RHODE ISLAND CONTRACT NO.2012-CB-001

Replacement of Central Bridge No. 018201 & Access Improvements to Route 114

NOTICE TO PROSPECTIVE BIDDERS

ADDENDUM NO. 1 Prospective bidders and all concerned are hereby notified of the following changes in the Plans, Specifications, Proposal and Distribution of Quantities for this Contract. These changes shall be incorporated in the Plans, Specifications, Proposal and Distribution of Quantities, and shall become an integral part of the Contract Documents.

BRIDGE DEMOLITION PLAN - 2

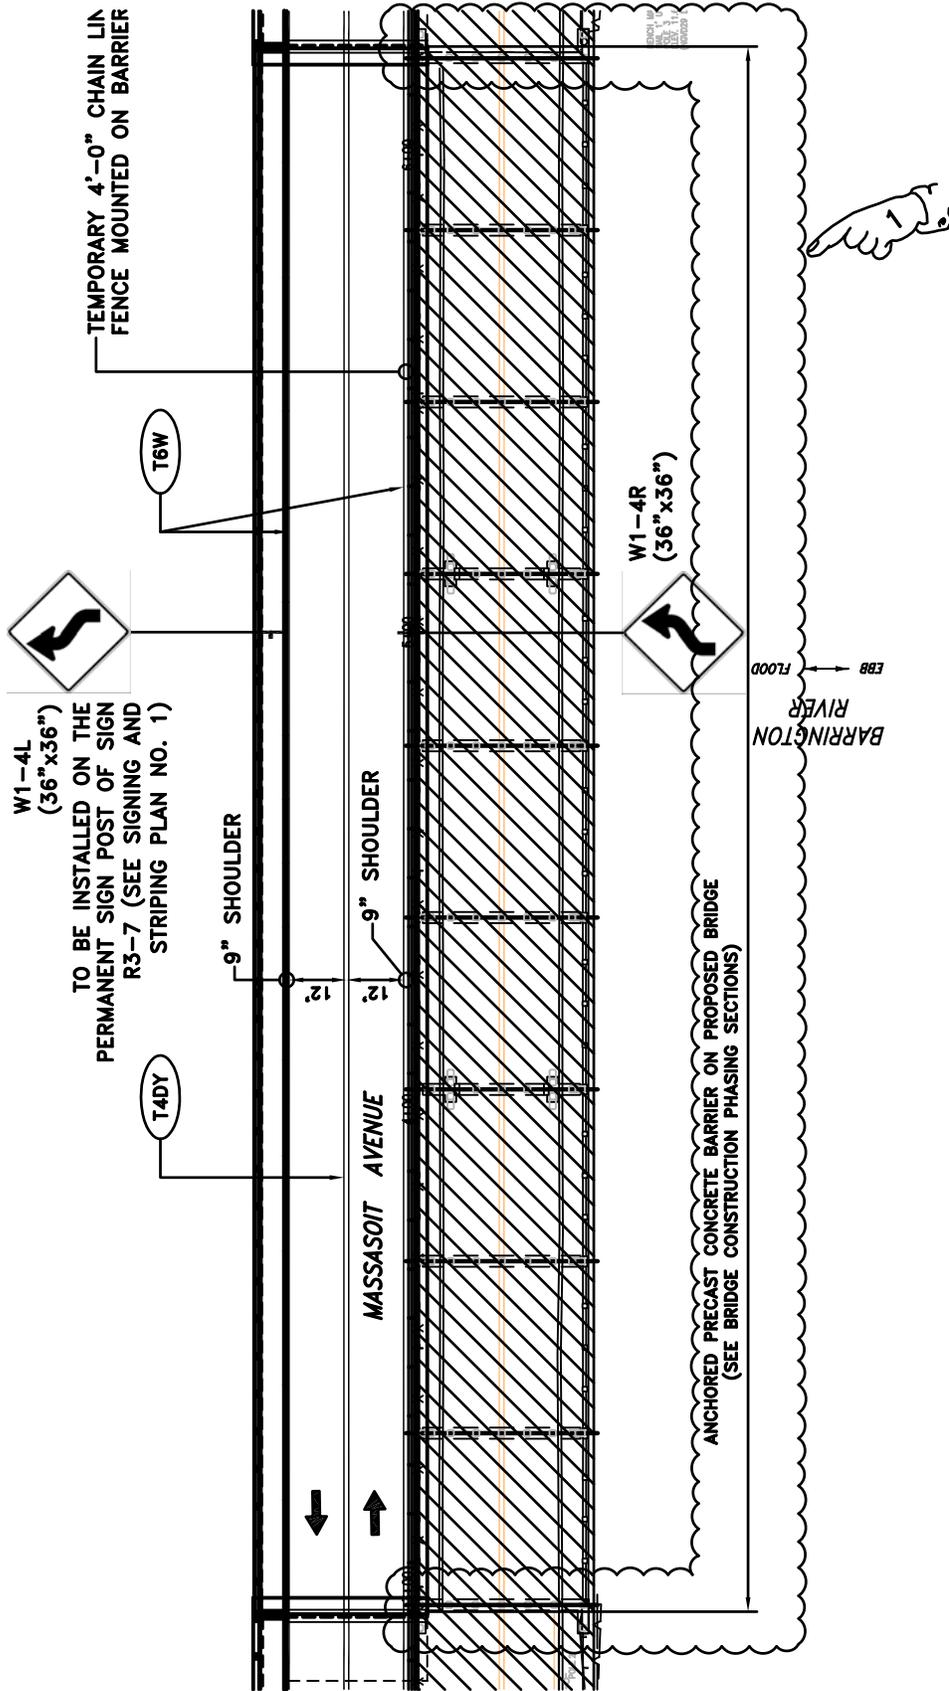
Sheets 37 and 38 of 103, Bridge Demolition Plans 1 and 2, are modified as shown in Sketches 1 and 2 attached to this Addendum No. 1. A note regarding included items of work has been added.

REVISION TO SHEET 23 of 103

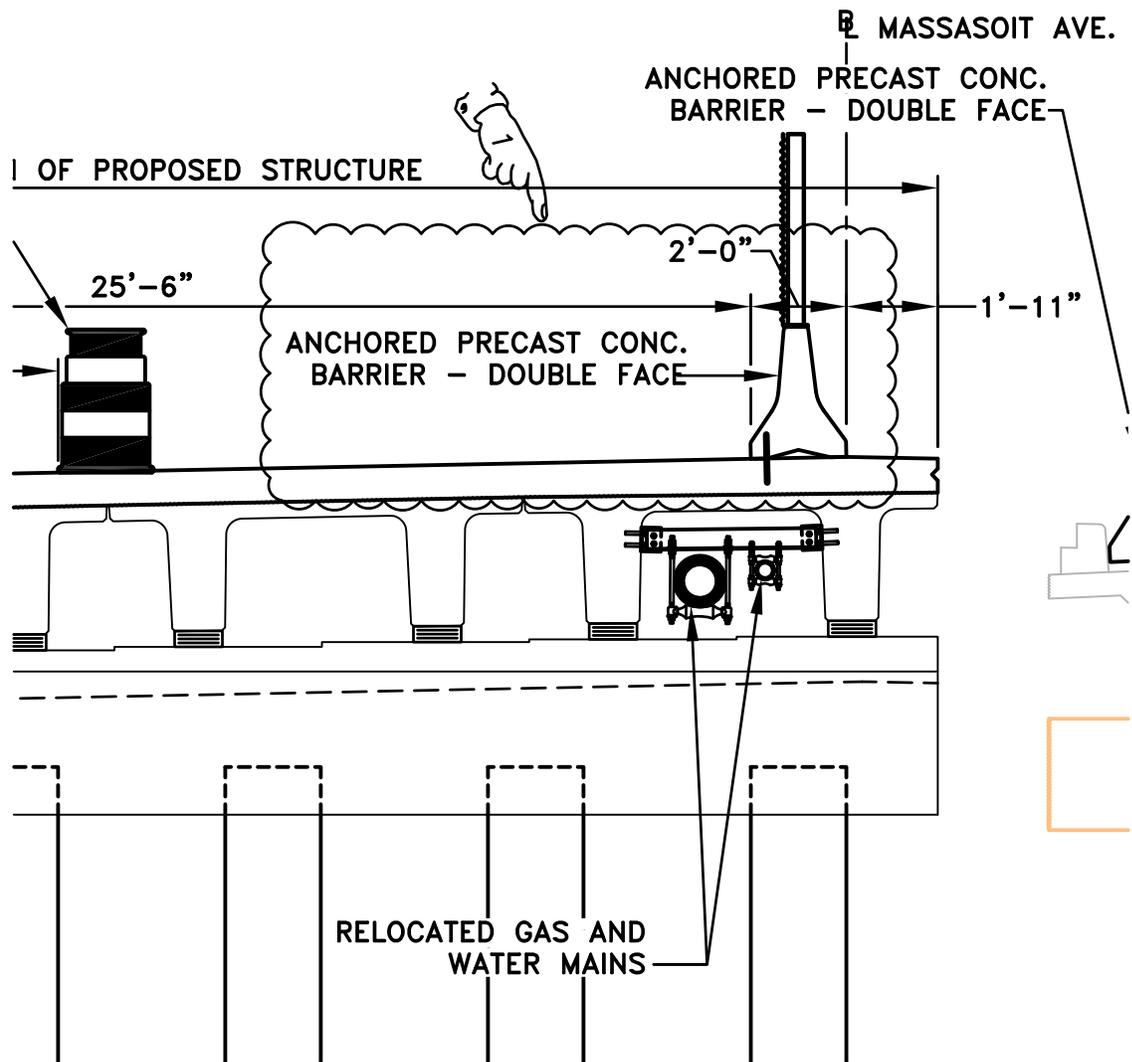
Sheets 23, 43, & 83 of 103 are modified as shown in Sketches 3-5 attached to this Addendum No. 1. The temporary precast barrier on the proposed bridge has been changed to Anchored Precast Concrete Barrier for Temporary Traffic Control.
